SUBJECT: Final Remedial Design Report for the Ash Landfill Operable Unit at Seneca Army Depot Activity; Contract FA8903-04-D-8675, Delivery Order 0012, CDRL A001G and A013

**Seneca Army Depot Activity
Romulus, New York**

**FINAL
REMEDIAL DESIGN REPORT
FOR THE ASH LANDFILL OPERABLE UNIT
SENECA ARMY DEPOT ACTIVITY**

PARSONS	
SENECA ARMY DEPOT ASH LANDFILL REMEDIAL DESIGN	
ENVIRONMENTAL ENGINEERING	DWG NO 744538-01400
FIGURE 7-3 LONG-TERM GROUNDWATER MONITORING DECISION DIAGRAM	
SHEET 1 OF 2	JUNE 2006

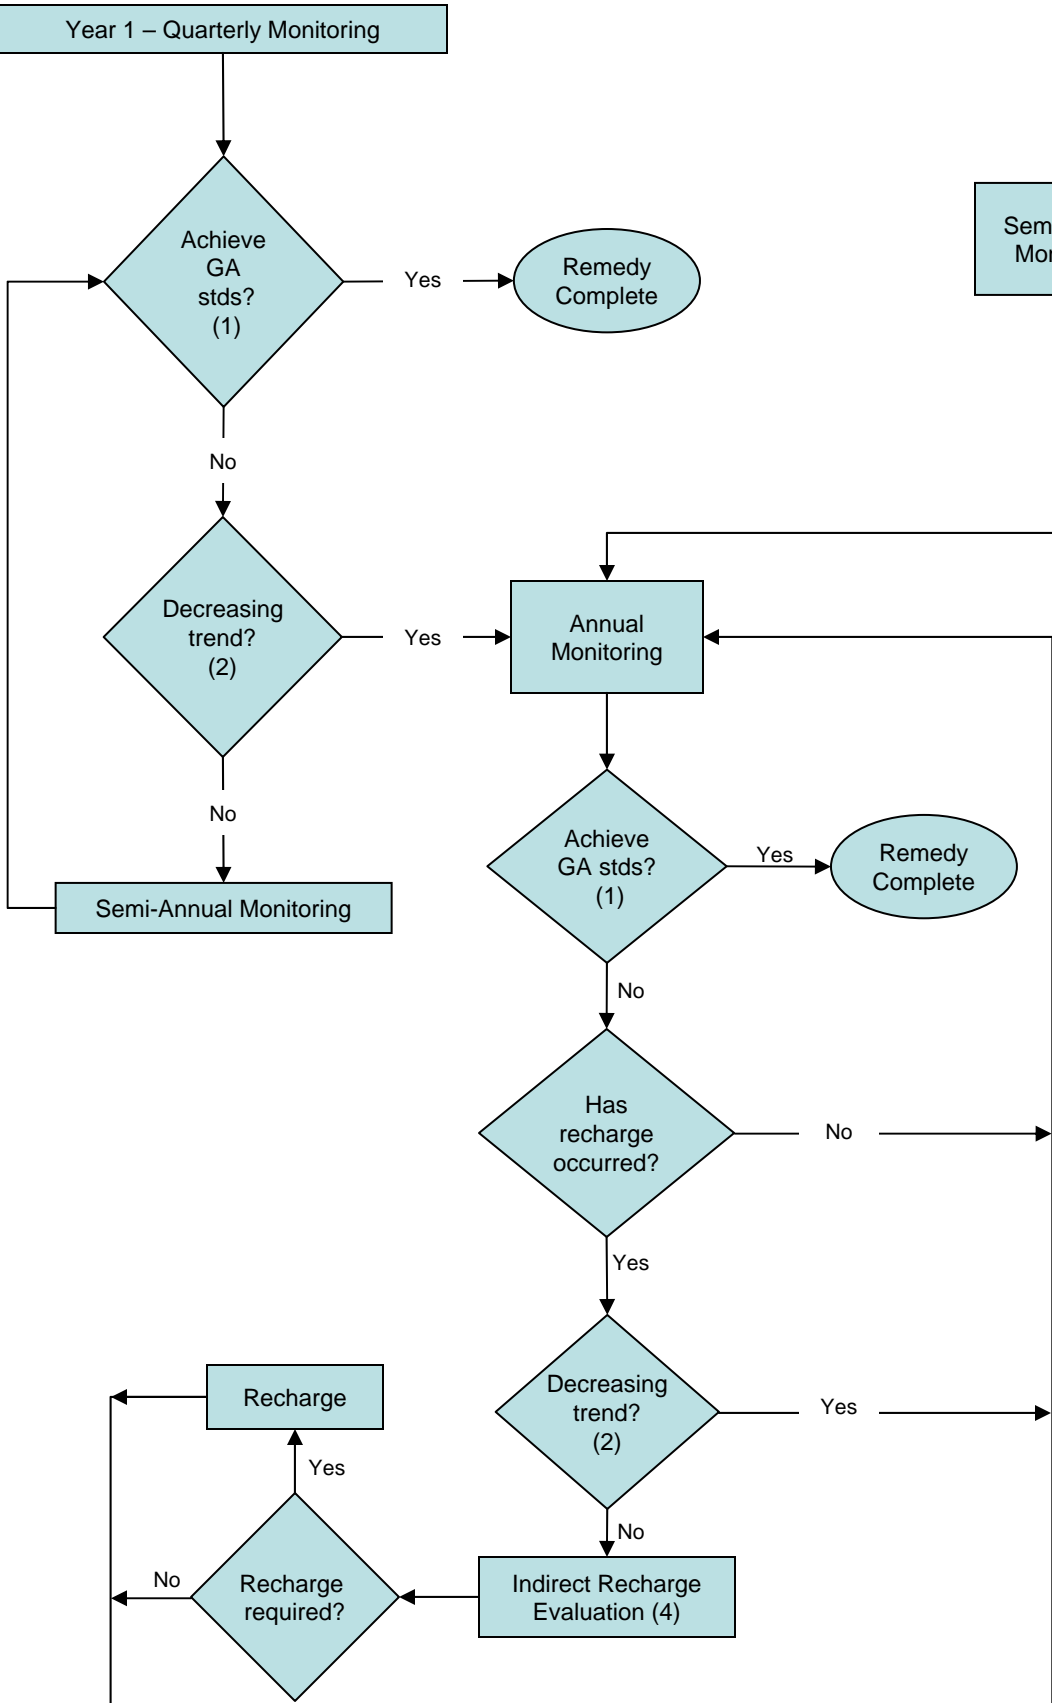
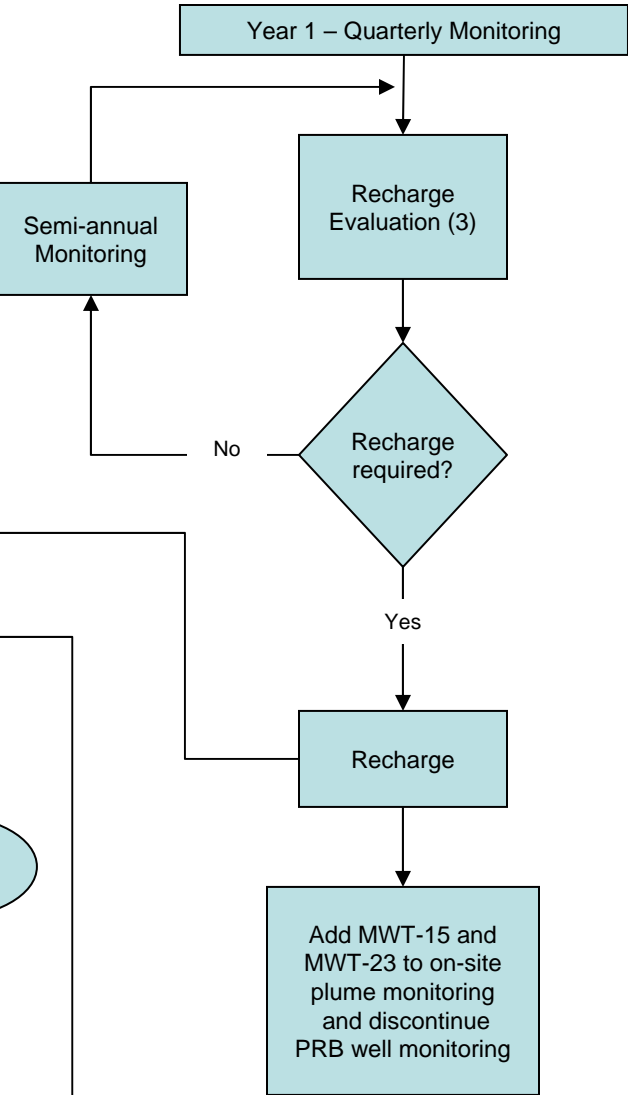
Figure 7-3, Notes, Item 1- Achieving GA Stds on site:

Response 1: The purpose of the long-term monitoring plan and, specifically, of the decision diagram outlined in Figure 7-3, is to establish a defined process for evaluating the groundwater monitoring program and for detailing the frequency and duration of monitoring. It is the Army’s desire that the long-term monitoring plan be definitive as to when monitoring requirements would terminate. The ROD states that monitoring will be conducted at the site until NYSDEC GA standards are achieved. The Army’s original wording provides a clear blueprint for when the GA standards in the on-site wells have been achieved. Currently, the Army has recommended that after two successive monitoring events, if GA standards are achieved in all on-site plume wells, the remedy would be complete and no further monitoring would be required for the Ash Landfill Operable Unit. Under the Army’s proposed plan, since monitoring would cease after two successive rounds of acceptable data as currently defined, there would not be a “subsequent” round. Therefore, the text in the note on Figure 7-3 remains unchanged.

Response 2: Graphs and statistics will be used, as appropriate, to determine the trend of the analytical data. The text in Figure 7-3 and on Page 7-5 has been modified.

SECTION A – BIOWALL PAIRS
N.T.S.

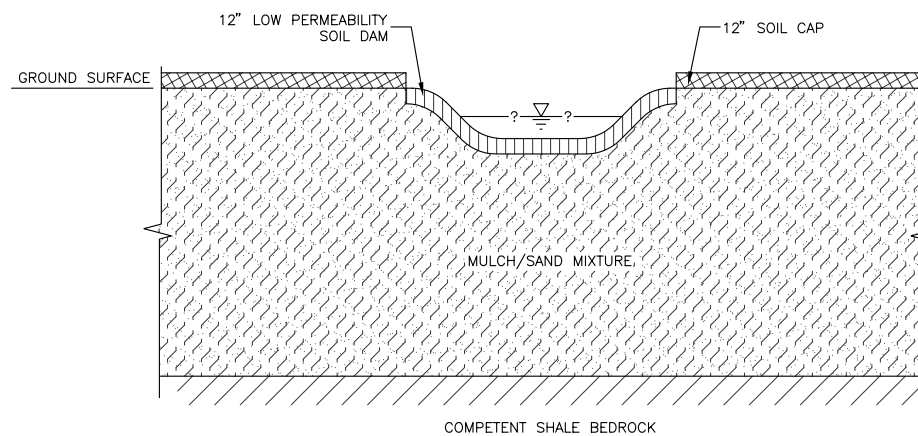
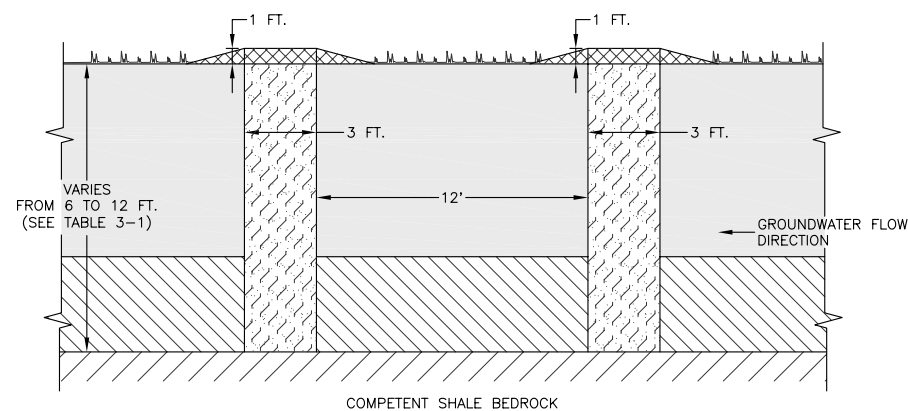
Comment 4, Page 4-9, Second paragraph: After "Drawing C-4", the text indicates the space between walls as 15 ft. However, the drawings show a space of only 12 feet. Please correct.

Response 4: The text in question has been modified to read: "The walls within each pair will be spaced approximately 15 feet apart measured from the centerline of each trench." Since each trench is three feet wide, this would translate into a 12-foot separation between the edges of each trench, as indicated in Drawing C-5.
